## HISTORIC AND DESIGN REVIEW COMMISSION

**HDRC CASE NO:** 2017-566  
**ADDRESS:** 402 CENTER ST  
406 CENTER ST  
139 N SWISS  
126 N CHERRY  
122 N CHERRY  
120 N CHERRY  
134 N SWISS  
130 N SWISS  
126 N SWISS

**TYPE OF WORK:** Conceptual approval of a site plan for a twenty-four unit townhome development  
**APPLICATION RECEIVED:** October 24, 2017  
**60-DAY REVIEW:** December 23, 2017

## Preliminary Site Plan

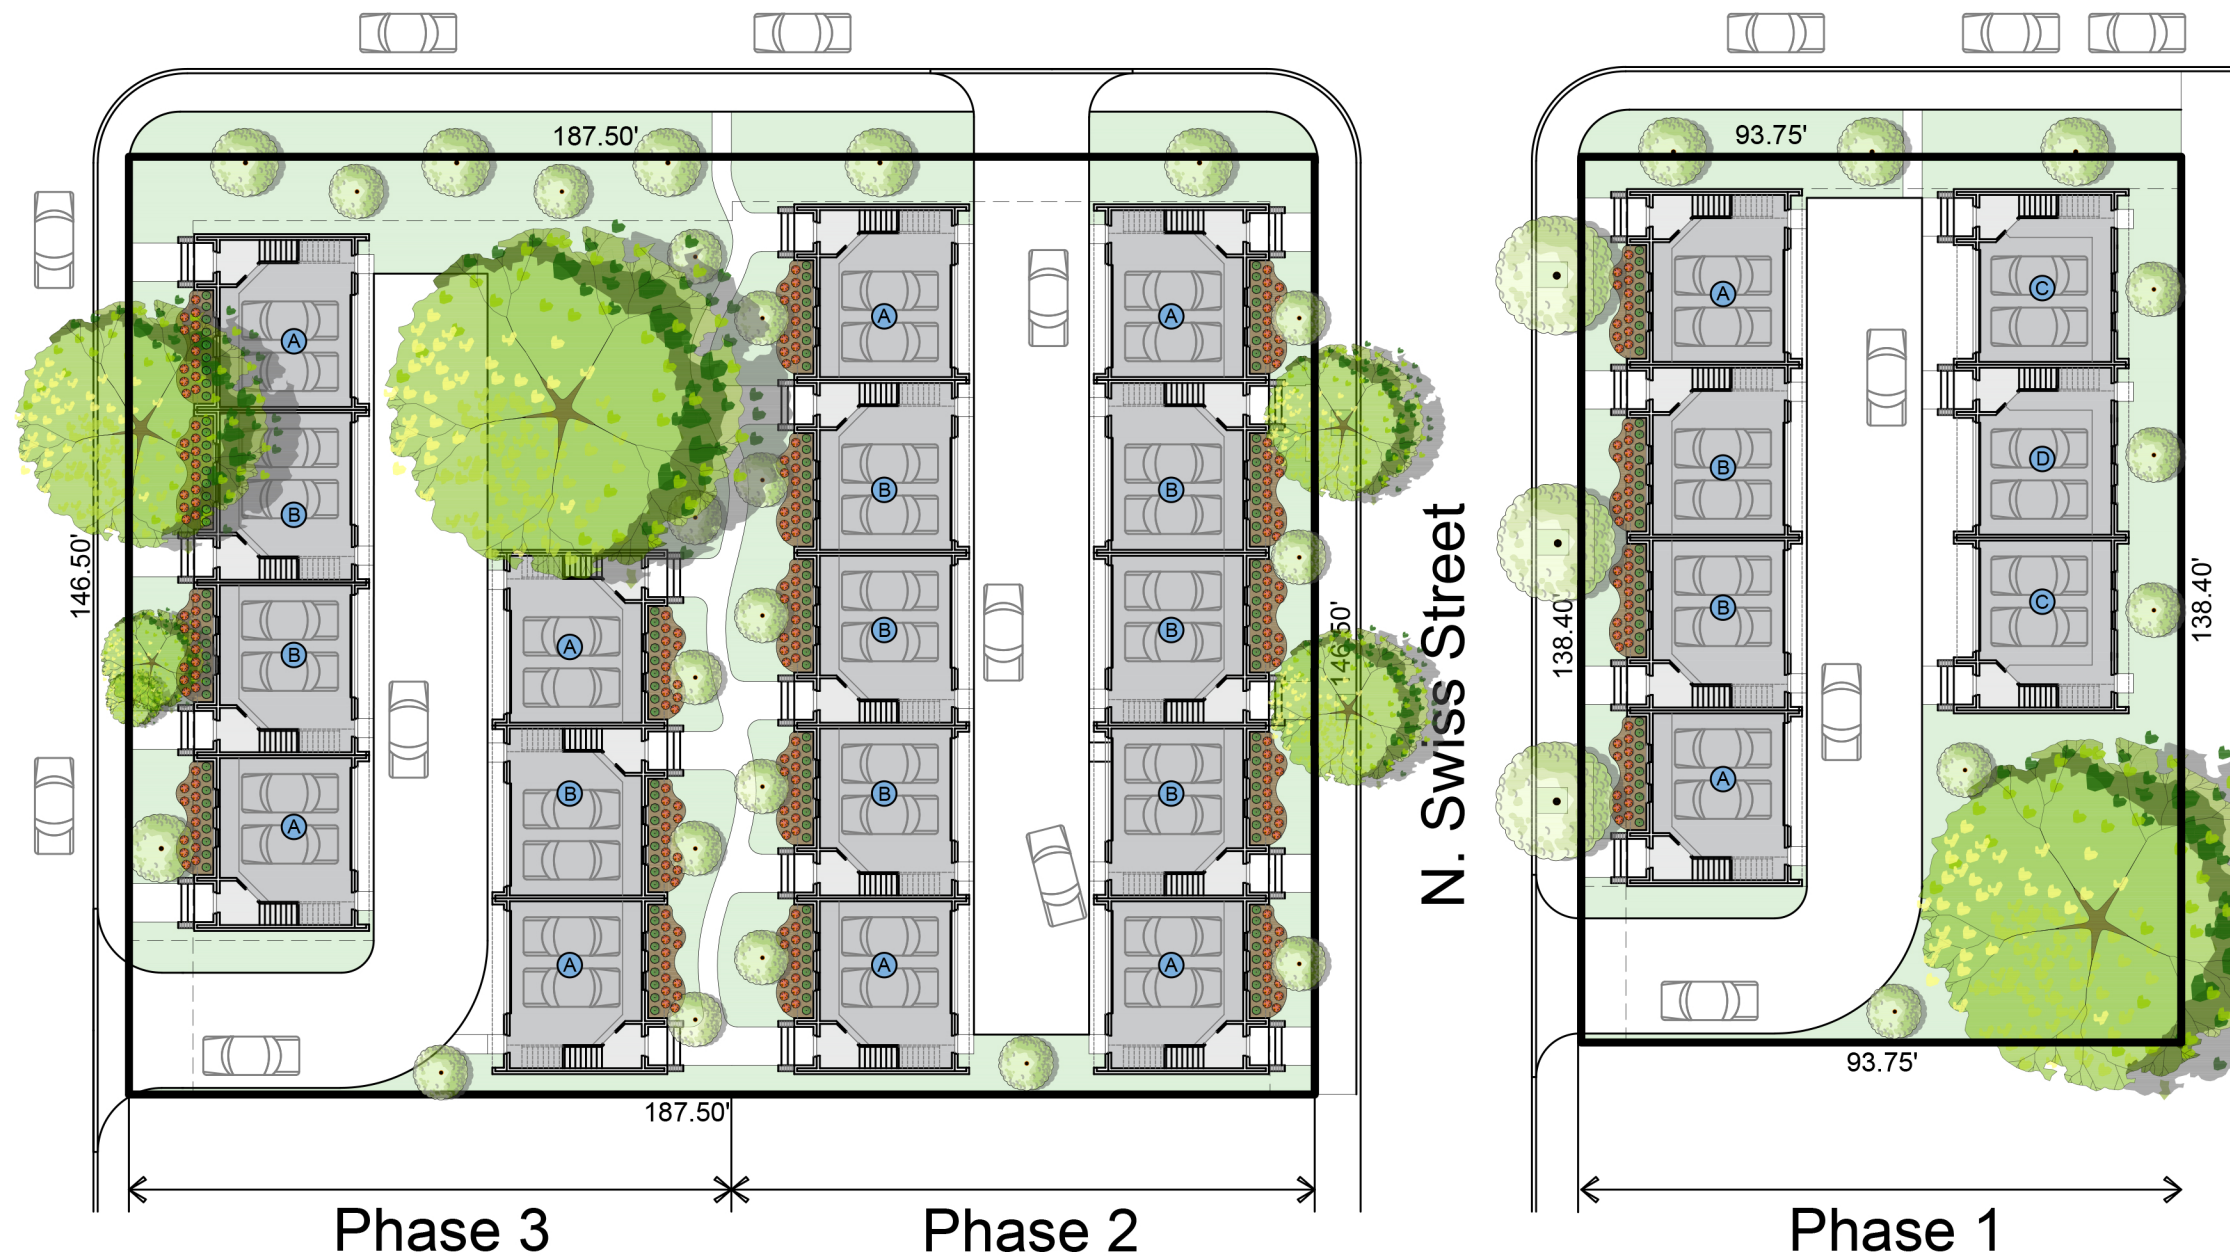
- d. **SITE PLAN** – The applicant has provided a site plan that notes that construction of twenty-four residential structures in row house form. The ground level of each structure features an automobile garage. The applicant has proposed for thirteen of the proposed units to front N Cherry Street or N Swiss.

- e. **SETBACKS** – Per the Guidelines for New Construction 1.A.i., the front facades of new construction should be aligned with the front facades of adjacent buildings where a consistent setback has been established along the street frontage. Where a variety of setbacks exist, the median setback of buildings should be used. The surrounding structures, many of which are not historic, feature varying setbacks. Staff finds that the applicant should provide a diagram noting the relationship of proposed setbacks with those found historically in the adjacent blocks. On N Swiss, the proposed new construction should feature a greater setback than the adjacent single family historic structure.

- f. **ORIENTATION** – The applicant has proposed an orientation that results in thirteen of the proposed twenty four units to front either N Cherry or N Swiss Streets. Eleven of the proposed units will feature an inward orientation. Generally, staff finds the units that have been proposed to front N Swiss and N Cherry to be appropriate and consistent with the Guidelines. There are currently four units that are adjacent to Center Street but do not feature an orientation toward Center. Staff finds that the applicant should incorporate porch and other architectural elements to reorient these units toward Center Street.

- g. **SITE DESIGN** – The applicant has noted the installation of natural lawn areas that are to include planting beds at the front of each structure. Additionally, the applicant has provided information regarding site design including the location of driveways, walkways and sidewalks and trees. Generally, the proposed locations of grass and plants are appropriate.

- h. **WALKWAYS** – The applicant has proposed sidewalks to extend between row structures as well as sidewalks to extend from front porches to the connecting sidewalks. Staff finds this appropriate; however, sidewalks that extend to Center Street should feature a width that is consistent with that found historically in the district.

- i. **DRIVEWAYS** – The applicant has noted driveway entrances that are to be located on N Cherry, Center and N Swiss Streets. Each of the propose driveway widths as well as curb cut and apron widths are wider than what is found historically in the district. Staff finds the location of the proposed driveways to be generally appropriate; however, staff finds that the applicant should provide additional information regarding exact widths, materials and curb cut and apron widths.

Staff does not recommend conceptual approval based on findings a through h. Staff finds that without information regarding building heights, massing or façade arrangement, staff cannot recommend conceptual approval. If the HDRC finds that the provided information is sufficient for conceptual approval, staff recommends the following be addressed:

- i. That the applicant provide a diagram noting the relationship of proposed setbacks with those found historically in the adjacent blocks.
- ii. That the proposed new construction which fronts N Swiss feature a greater setback than that of the neighboring historic structure.
- iii. That units which feature a side elevation toward Center Street be reoriented to feature a primary orientation

toward Center.

- iv. That all sidewalks which intersect the sidewalk at Center feature a width and profile that is consistent with those found historically in the district.
- v. That the applicant provide information regarding the width, profile and materials of each driveway, apron and curb cut.
